APPROVED DRAWINGS HAVE BEEN RED LINED INDICATING A CHANGE TO MEET THE OBC. PLEASE REVIEW ALL PAGES TO ENSURE YOU ARE PROPERLY INFORMED OF CHANGES.

TOWNSHIP OF NORTH DUMFRIES BUILDING DEPARTMENT

These Plans have been examined for Compliance with the Ontario Building Code requirements. A Building Permit has been Issued, subject to any changes noted, under the condition that the building will be constructed in accordance with the code.

Tice River Homes
Legacy

LEFT SIDE ELEVATION 'A'

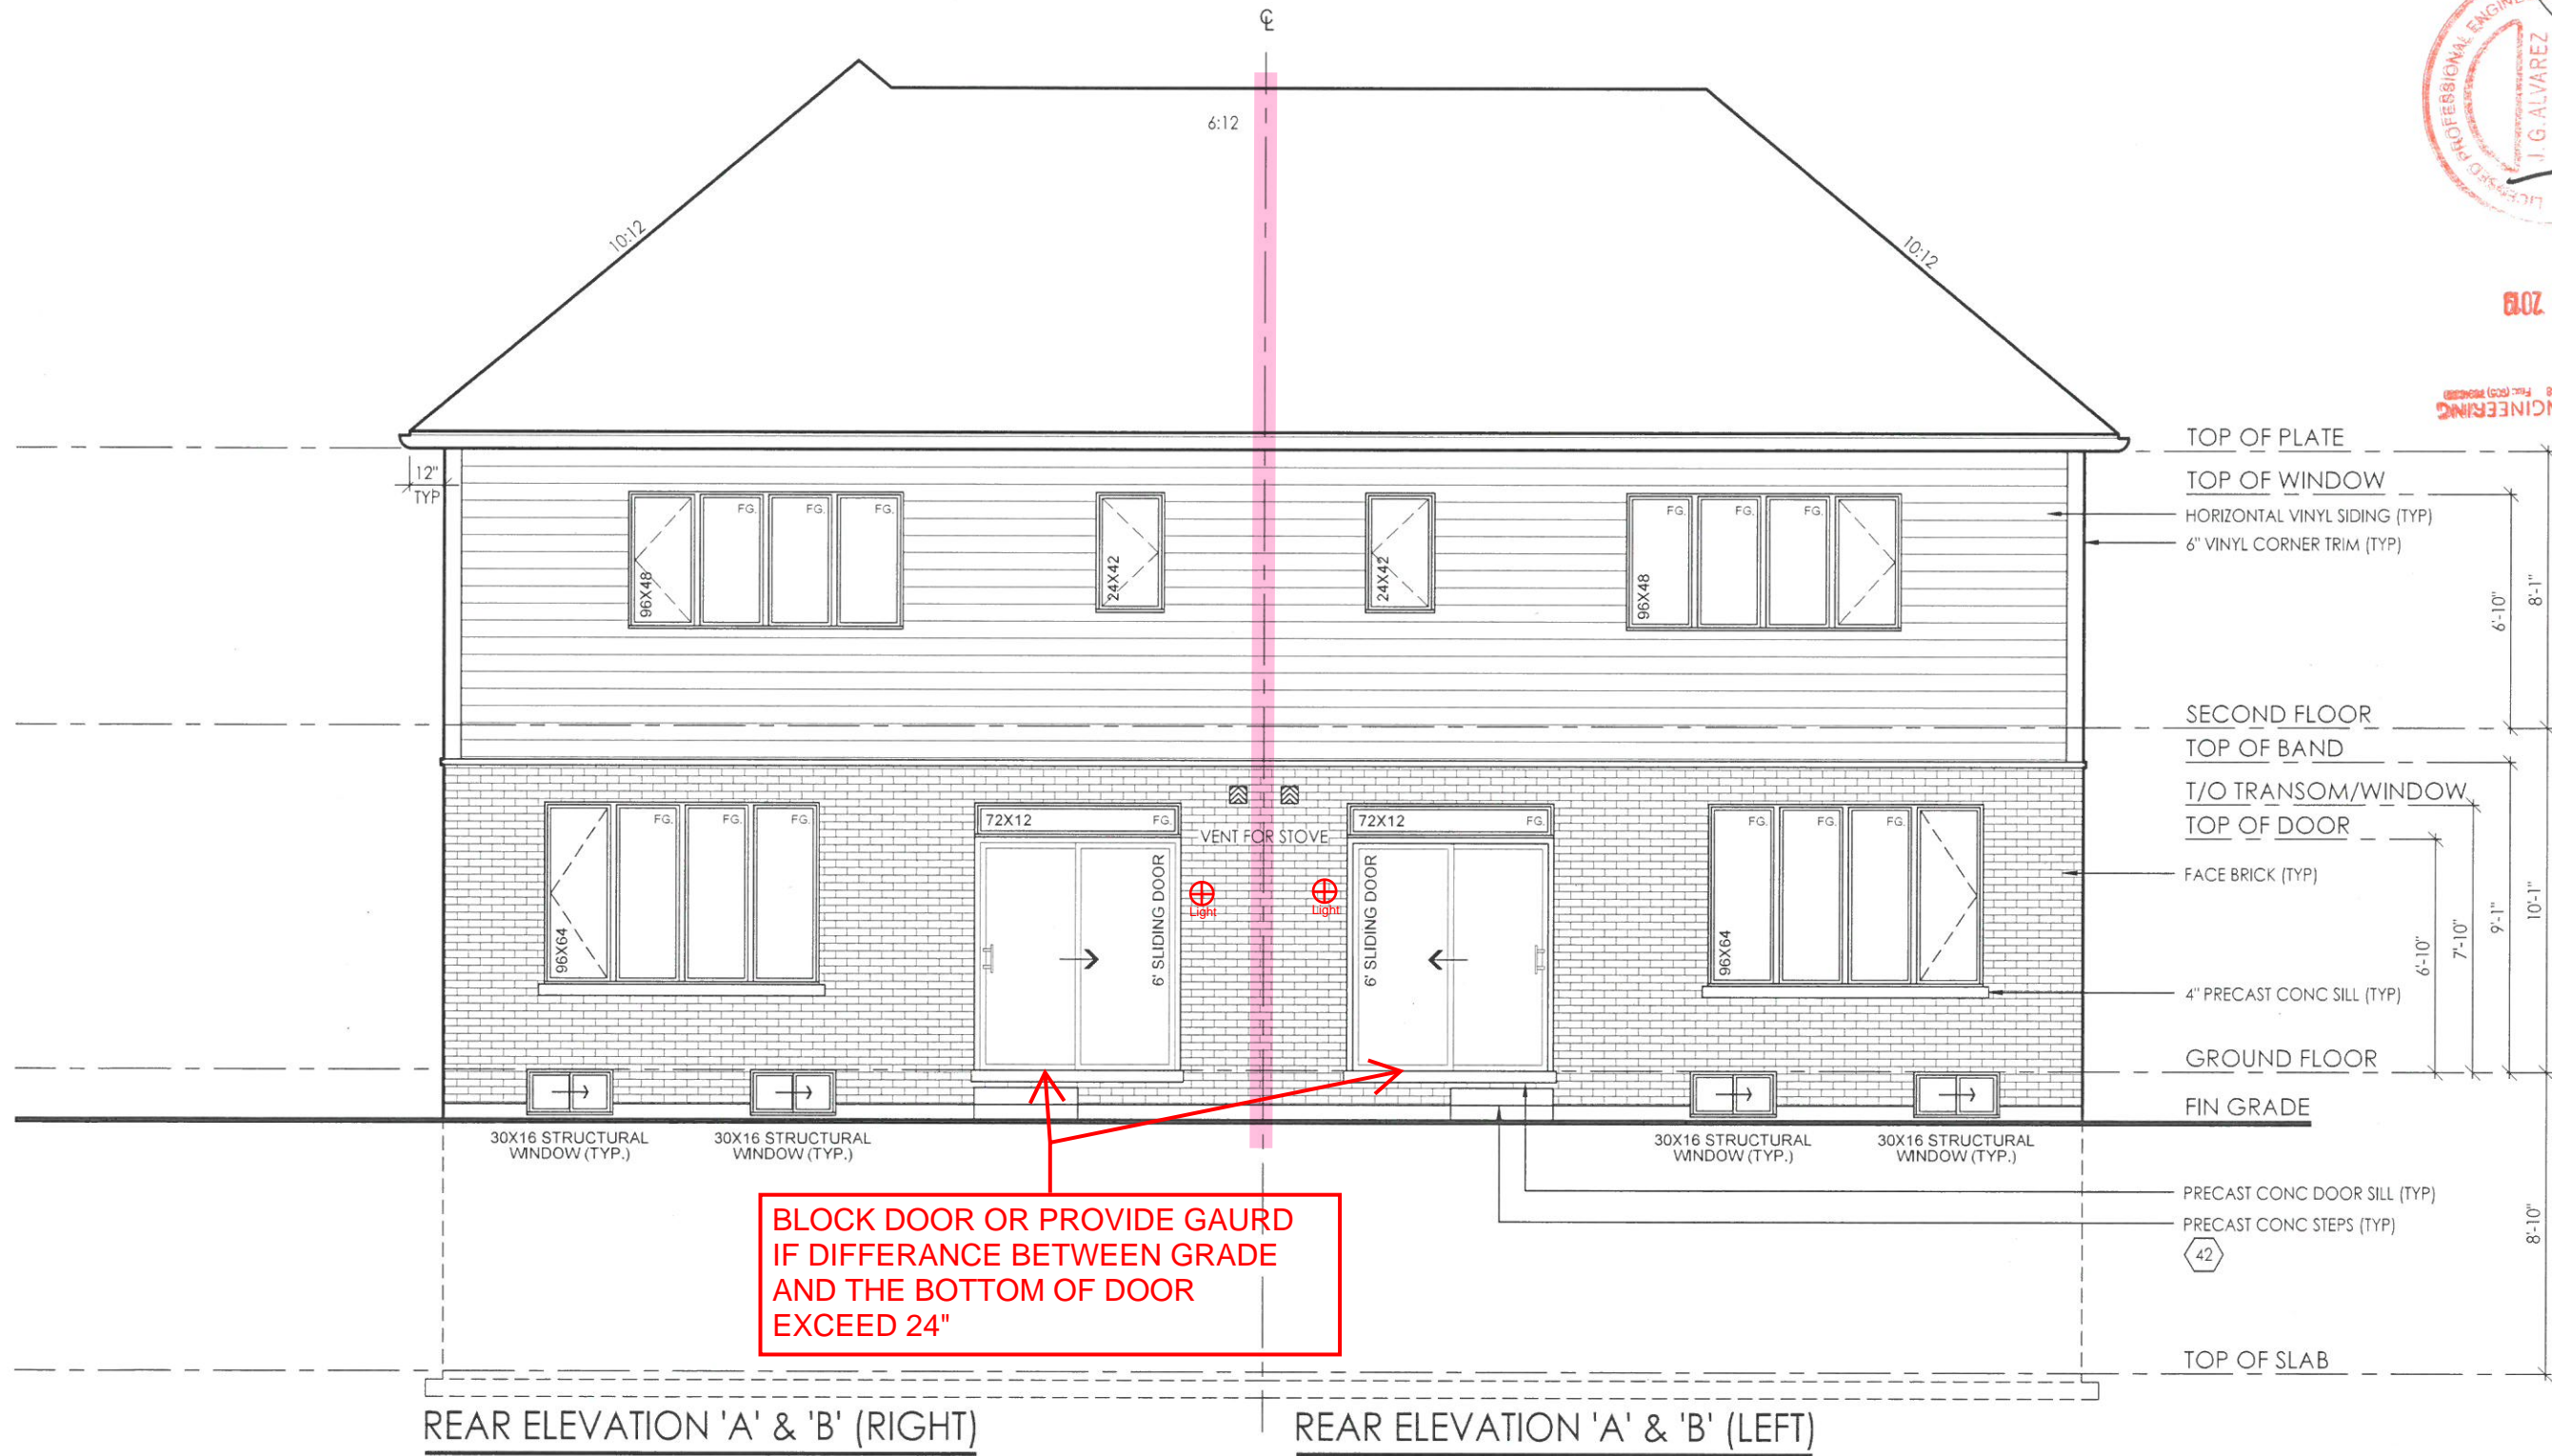
**BLOCK DOOR OR PROVIDE GAURD
IF DIFFERANCE BETWEEN GRADE
AND THE BOTTOM OF DOOR
EXCEED 24"**
